**Response to Comments**  
**on the**  
**Draft NEWIOU Feasibility Study**

## Response to CIWMB Comments on the Draft Feasibility Study for the NEWIOU

**Table C-10**  
**Time to Cleanup Results**  
**(50 ft/yr, Downgradient Section of Plume)**

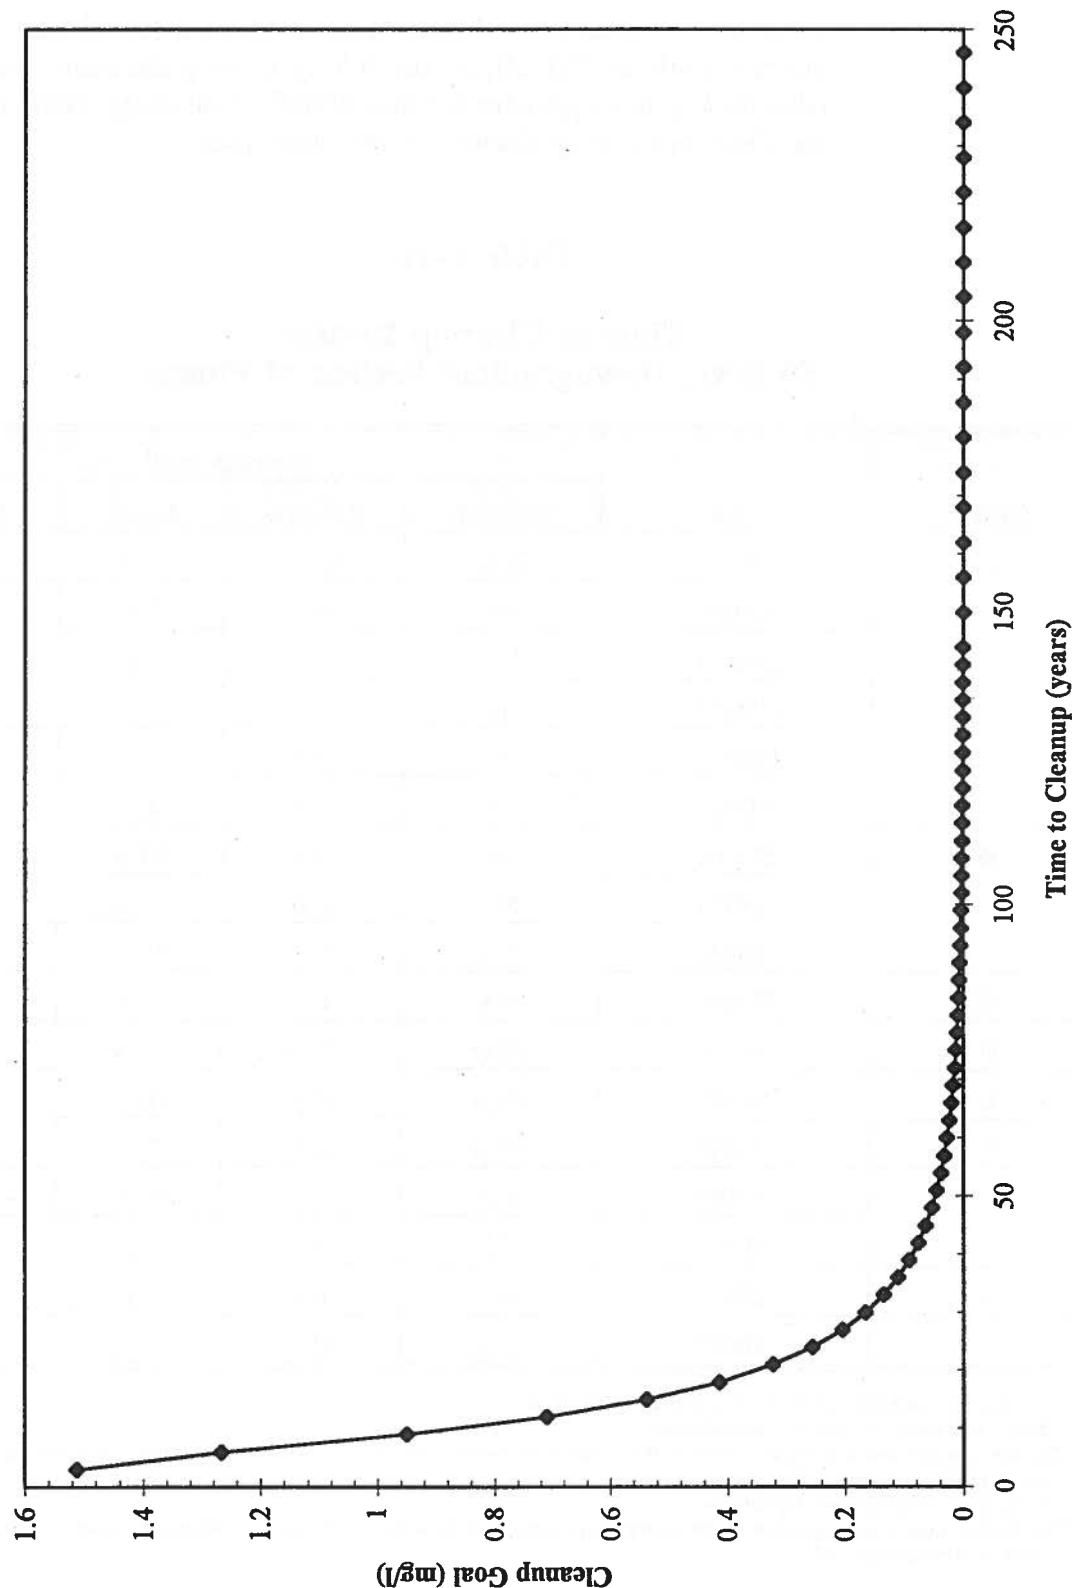
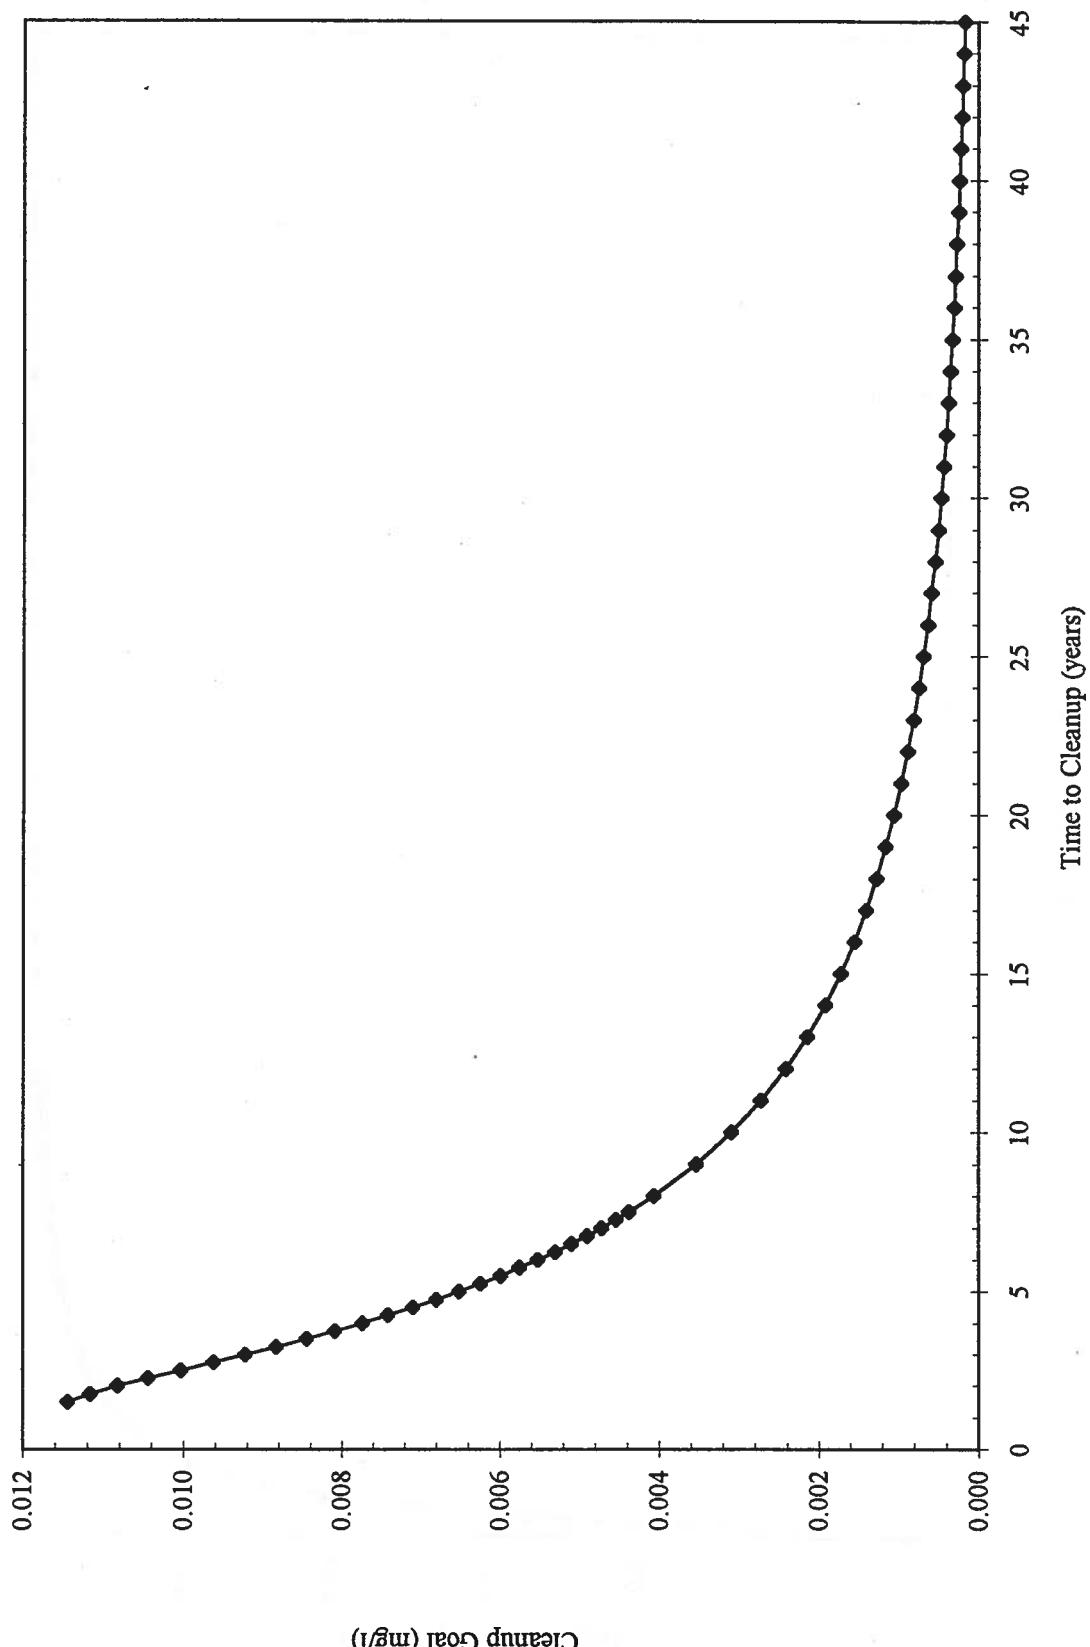
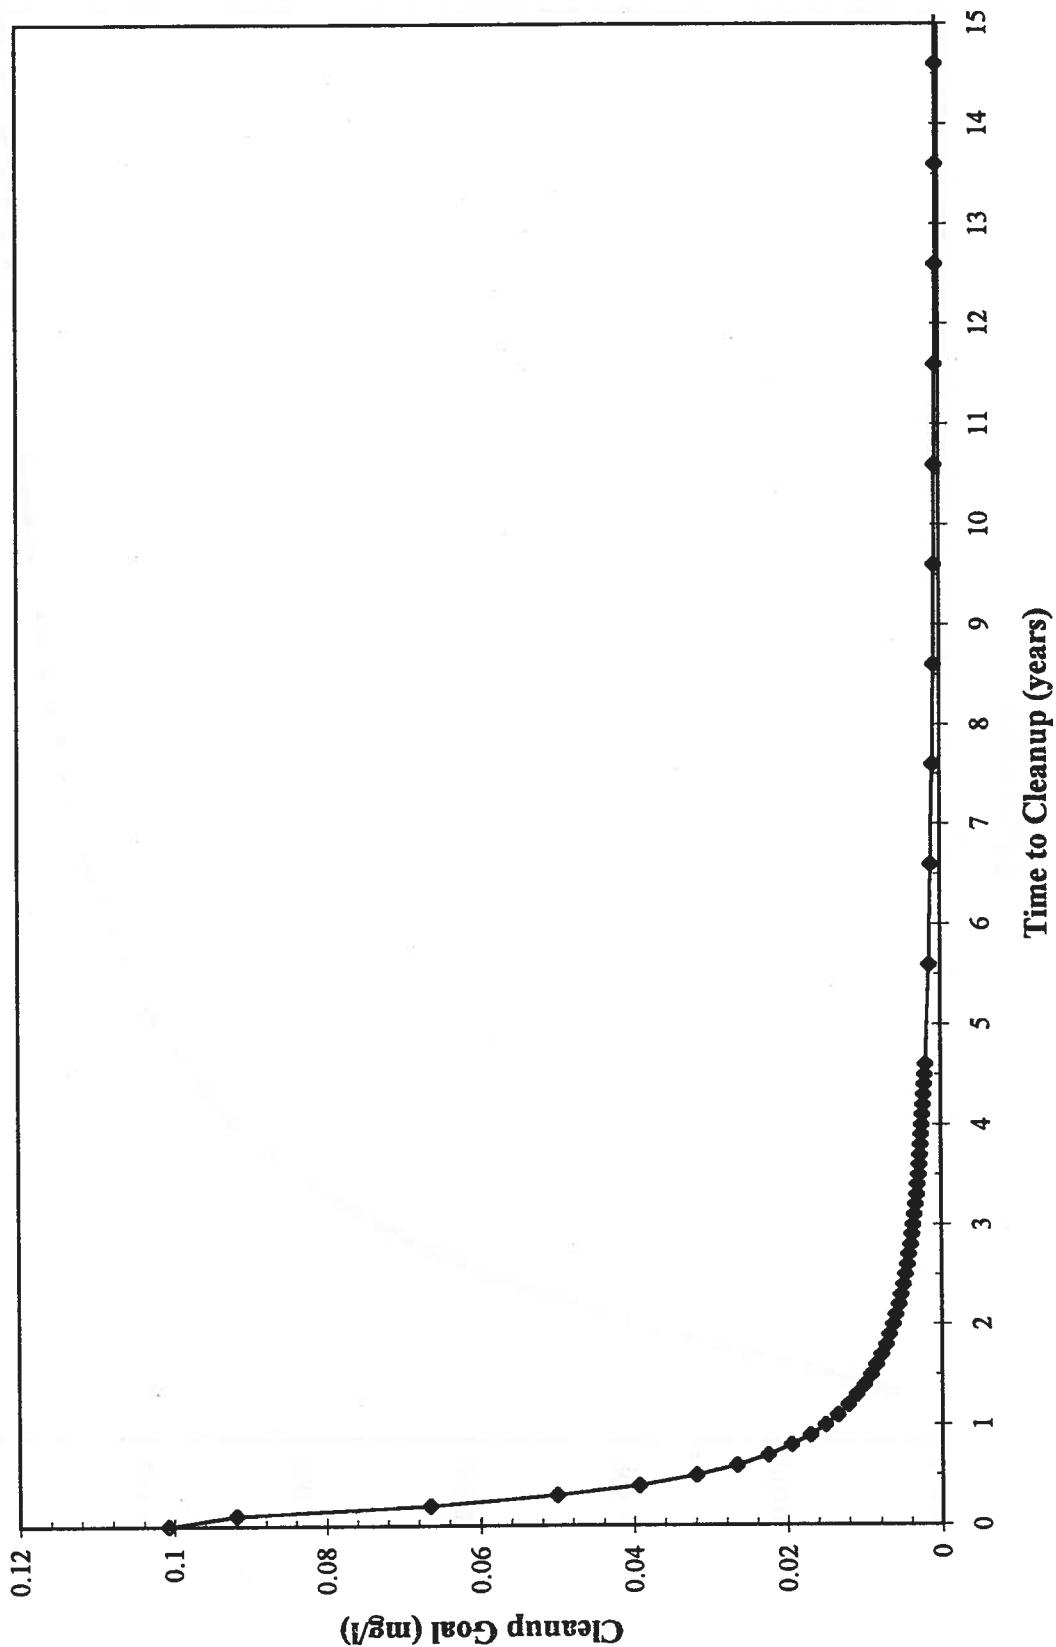
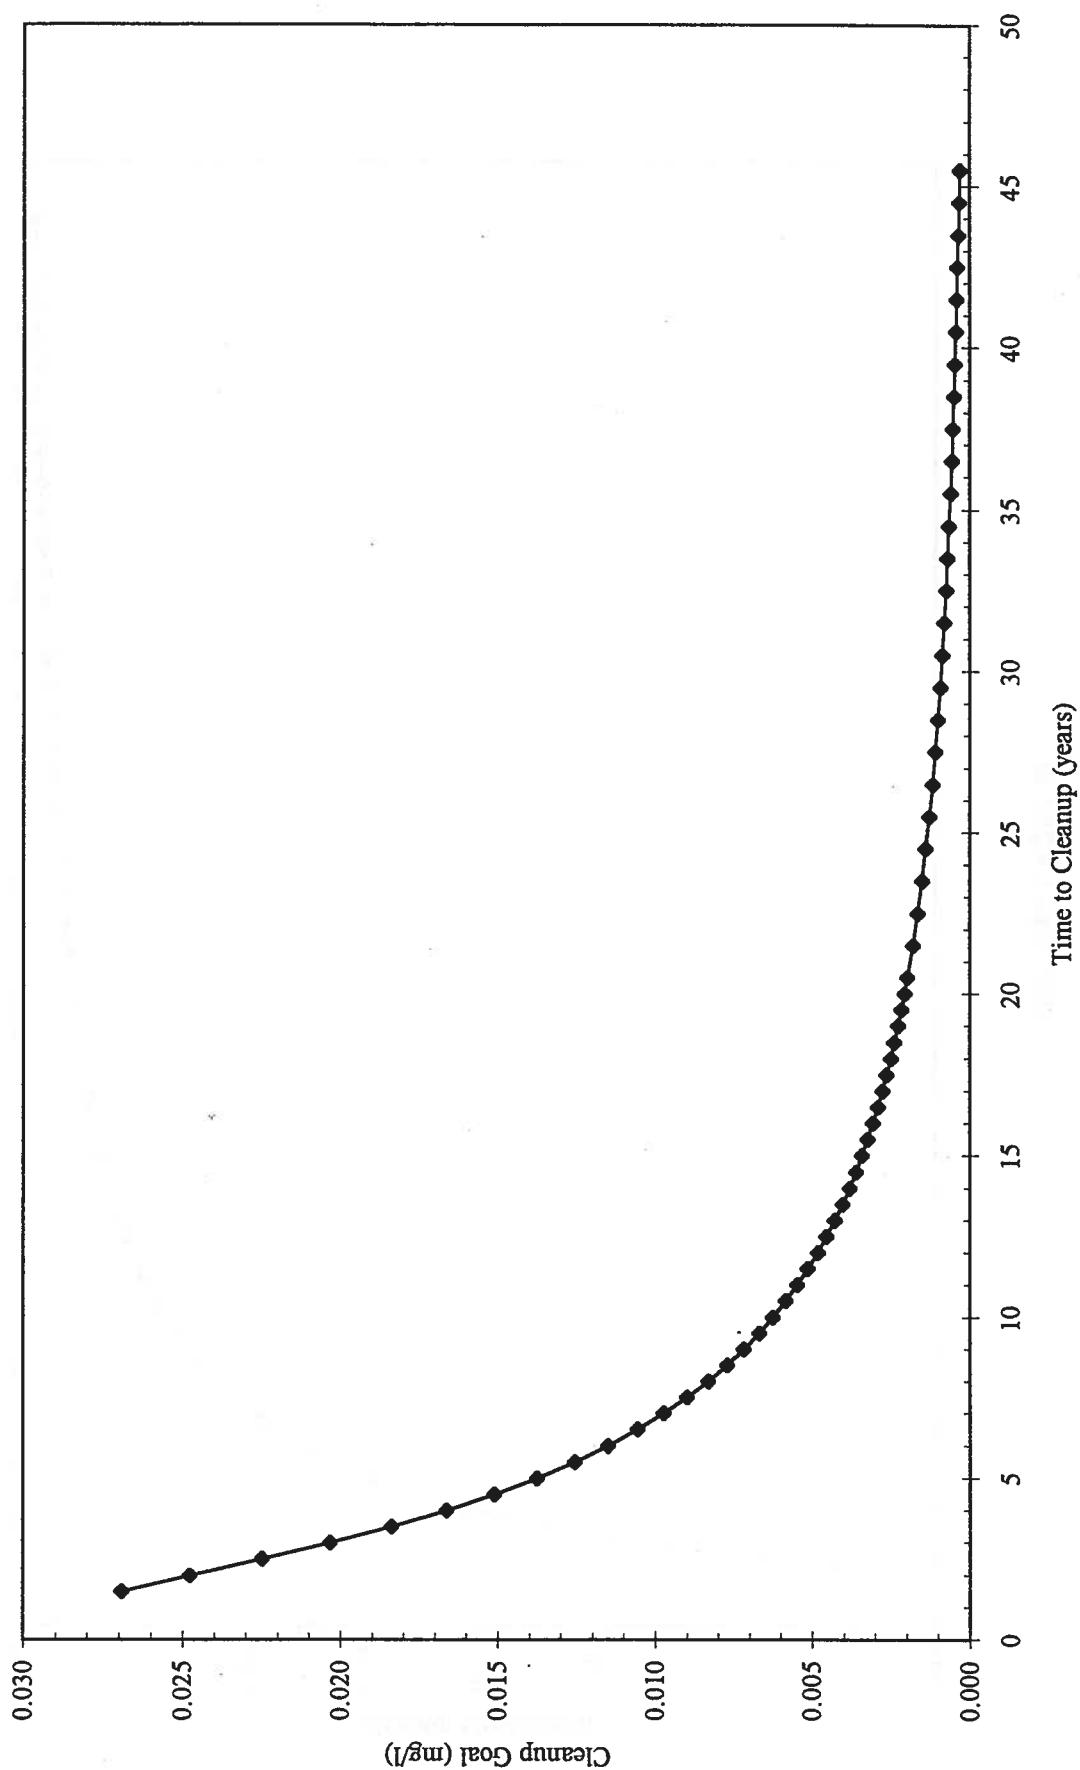
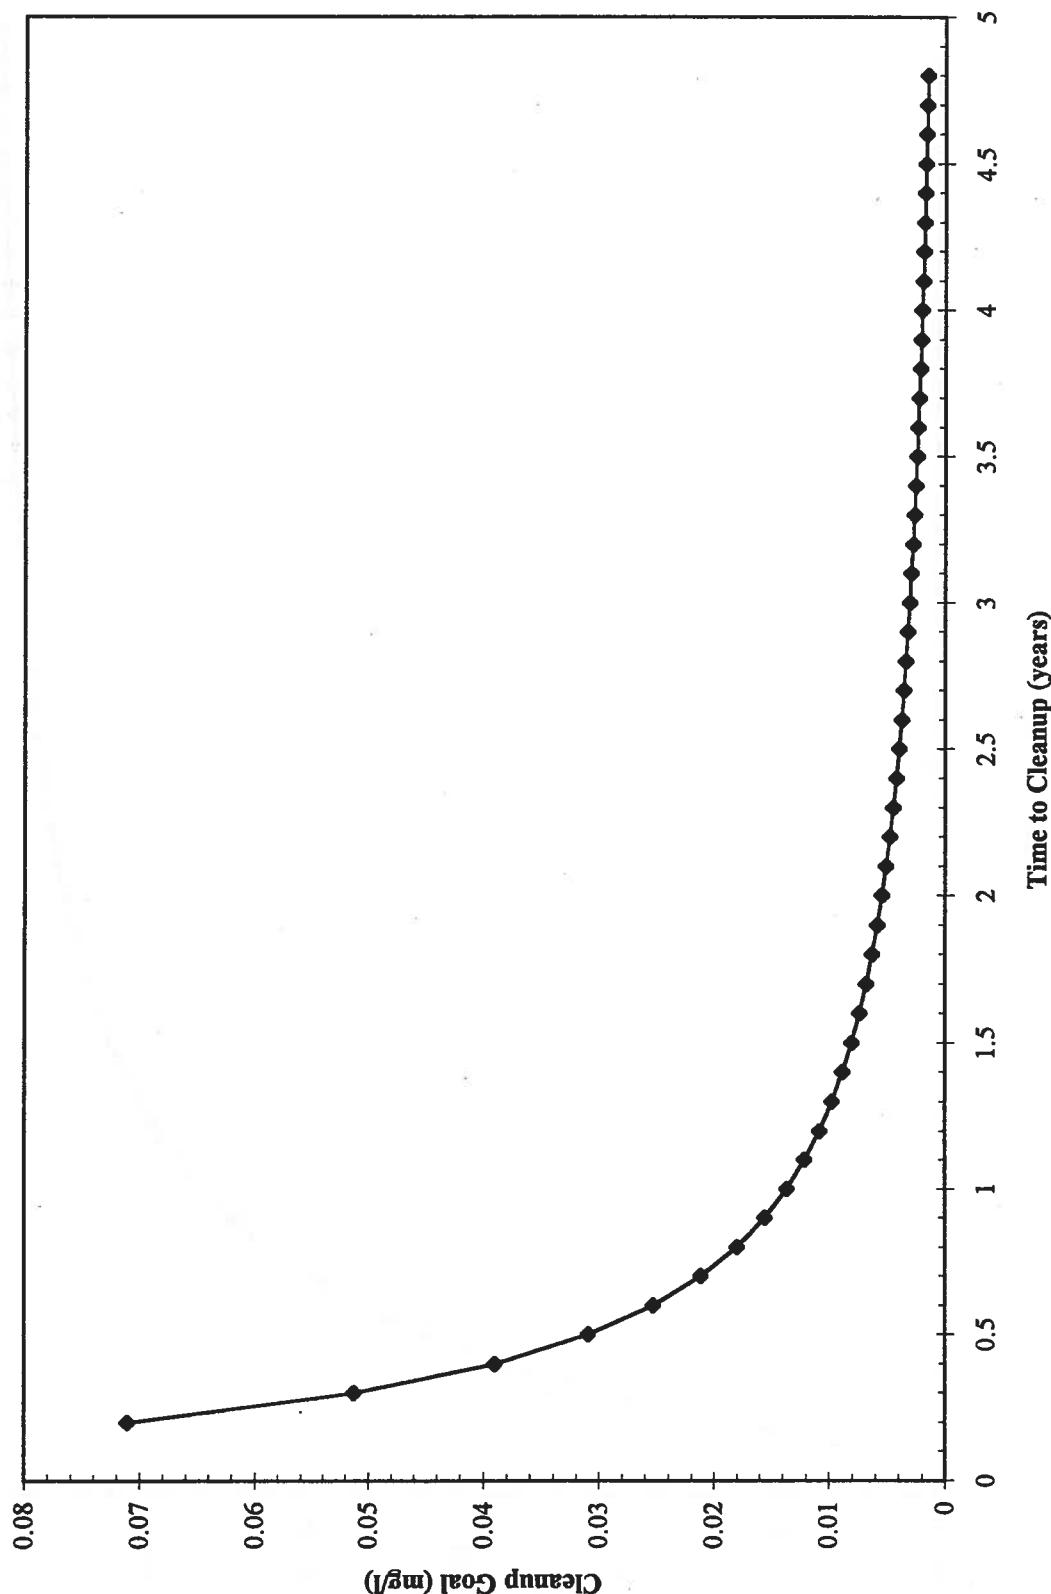
No.	Comments	Responses/Notes
13	<p><b>Appendix C, Time to Cleanup Determination Procedure</b></p> <p><b>Table C-10, Time to Cleanup Results</b></p> <p>For Group A sites, LF007B, LF007C, and LF007D, there is an apparent discrepancy in the calculated time to clean up the corresponding plumes and the relative size of those plumes. For example, the plumes under LF007D and LF007B are larger than the plume under LF007C and yet the calculated clean up time for LF007C is approximately ten times greater than LF007D and LF007B. DTSC recommends that the calculations be redone to check for possible errors. If the calculations are correct, then a discussion is needed to explain why there is such a large variation in cleanup times between LF007C and LF007B/LF007D. Any changes made to this table will also require modification of corresponding figures and discussion in the rest of the report.</p>	<p>The calculations for LF006 and LF007C were incorrect. The times to cleanup LF006 and LF007C should be lower. These times to cleanup have been corrected. In addition, an explanation of the following differences will be added to the Appendix: LF007B and LF007D were modeled based on chlorobenzene, while LF007C was modeled based on TCE, as noted in the summary table. In addition, LF007B and LF007C were modeled for linear flow through the plume, while LF007D was modeled for radial flow from the center of the plume.</p>
